FROM: Mitesh Baxi
Traffic Engineering

■ **SIR TYLER DR PARKING LOT EXPANSION [TRC Plan Review #3]**

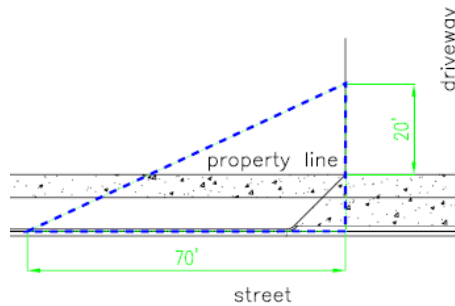
1. The sight distance triangle is not implemented correctly. Revise the City's 20'x70' sight distance triangles at the driveway as per below image. [Sec.18-529(c)(3)CofW LDC] You may show the revision along with the final submission set, a separate review is not required.
